\FRAMINGPLAN FOR PROPOSED NEW FLOORING & PARTITION WALLS

AS NOTED S-100

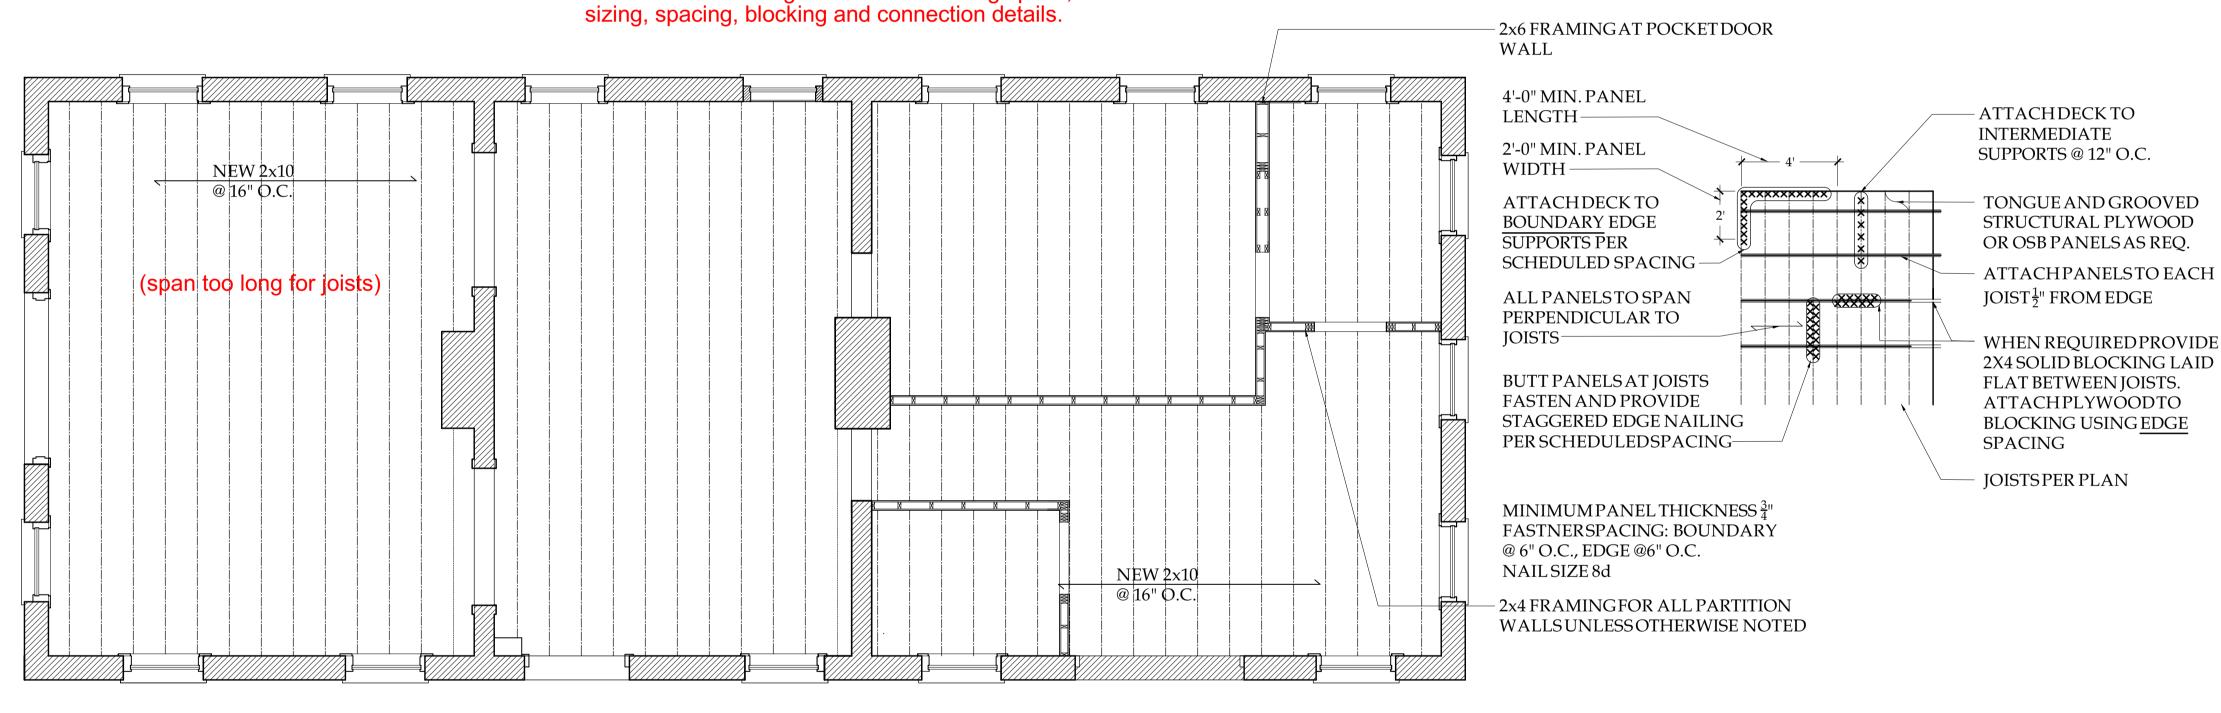
(Is there new framing at ramp and deck?)

- Please provide structural plans, sections and details stamped by a professional engineer including (but not limited to) the following:

1. Extent and details of any concrete and/or masonry work.

2. All new framing (girders, beams, headers, joists, posts, studs, etc.) with sizes, spacing, spans, blocking and connection details.
